ITEM 7. DEVELOPMENT APPLICATION: 11 BELLEVUE STREET GLEBE

FILE NO: D/2009/1733

Summary: Alterations and additions to rear of attached terrace including new second floor balcony and extension of bedroom at basement level.

Plan 2: Rear elevation (location of proposed balcony shown dashed)

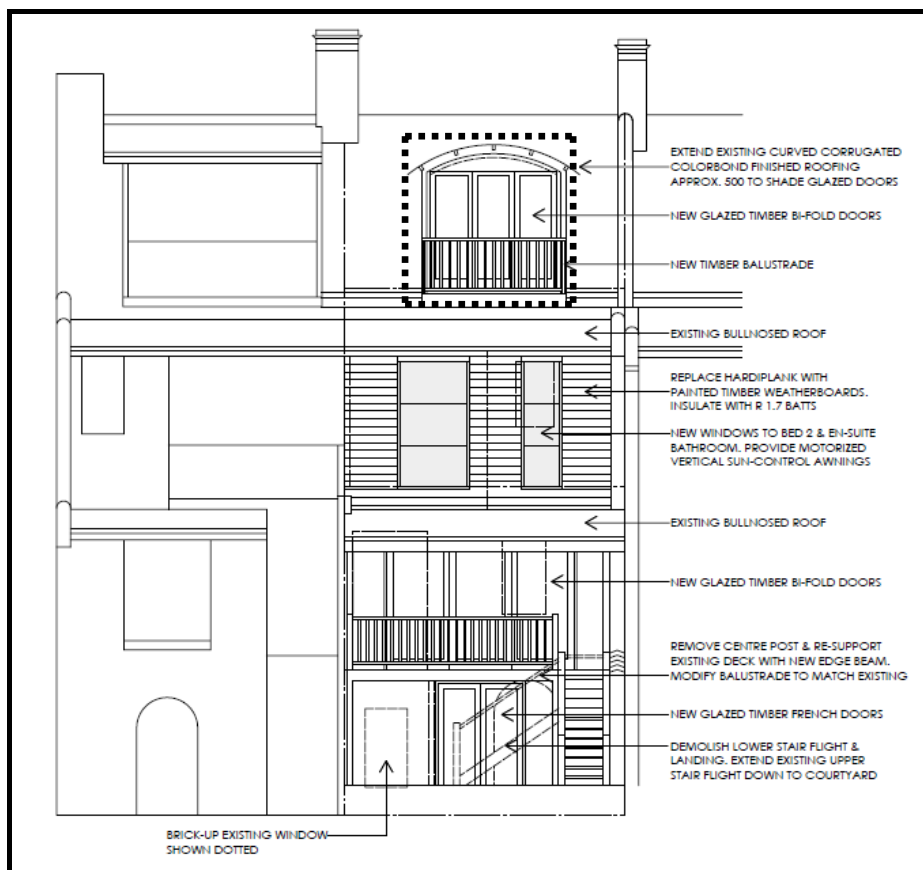
27. The proposed second floor rear balcony to the attic room is 1500mm by 2600mm with timber privacy screens to both sides. A condition of consent is recommended to reduce the depth of the balcony from 1500mm to 1200mm. The balcony is located off a low-trafficable bedroom. The balcony is positioned to over look roof tops and tree canopies. Its siting and orientation, the proposed screening devices and recommended conditions of consent to reduce the depth of the balcony will ensure that the proposal will not create any adverse visual or acoustic privacy impacts.

- (a) The depth of the second floor rear balcony shall be reduced from 1500mm to 1200mm.

Plan 3: Proposed Section (location of proposed additional floor space shown dashed which is created through excavating and does not increase the overall bulk of building).

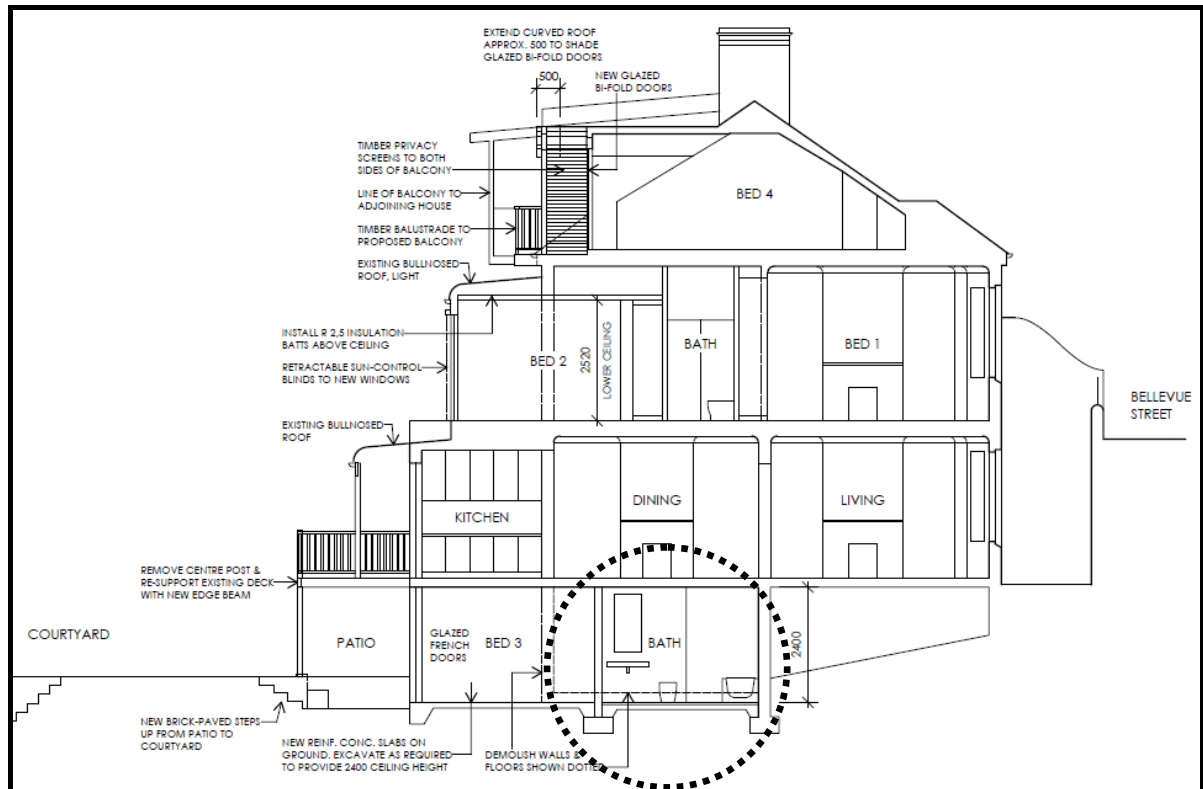
22. The above table illustrates the increase of 15m².
23. The additional 15m² of proposed floor space to the basement level will not affect the overall bulk of the dwelling as it is situated within the existing building footprint.

46. The SEPP 1 variation is supported as it would vary little from current conditions by creating an additional 15m² within the basement level to accommodate for a new bedroom and bathroom which does not affect the overall bulk and scale of the existing dwelling as the building footprint remains the same.

Figure 5: Bellevue Lane street alignment

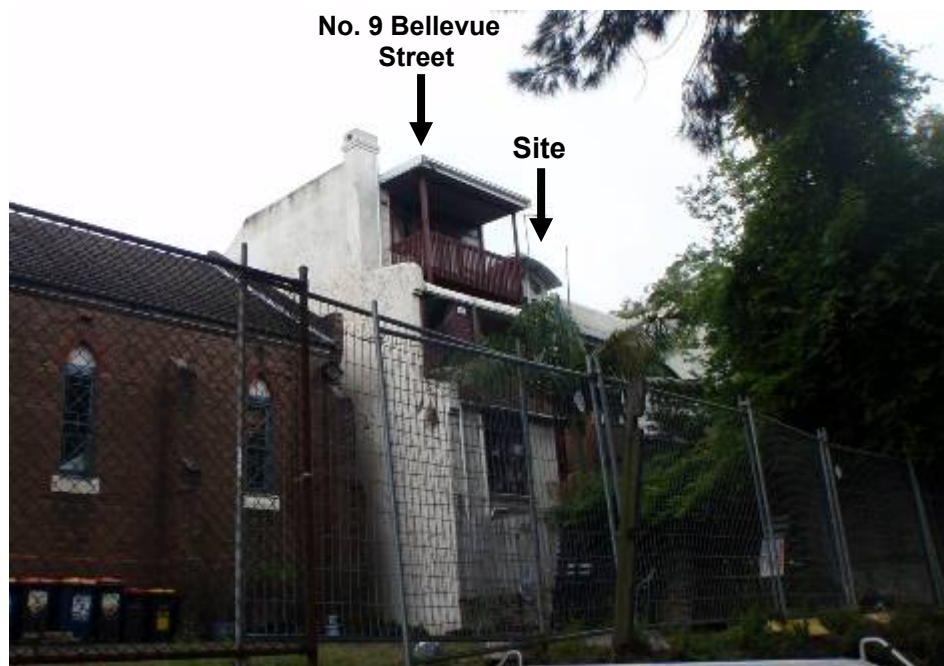
26. The proposal is sympathetic to the existing setbacks on adjoining properties. The proposed rear addition does not extend beyond the rear building alignment of No. 9 Bellevue Street which can be seen from Bellevue Lane as shown in Figure 5 below and will therefore not affect the bulk and scale of the dwelling as viewed from the laneway.
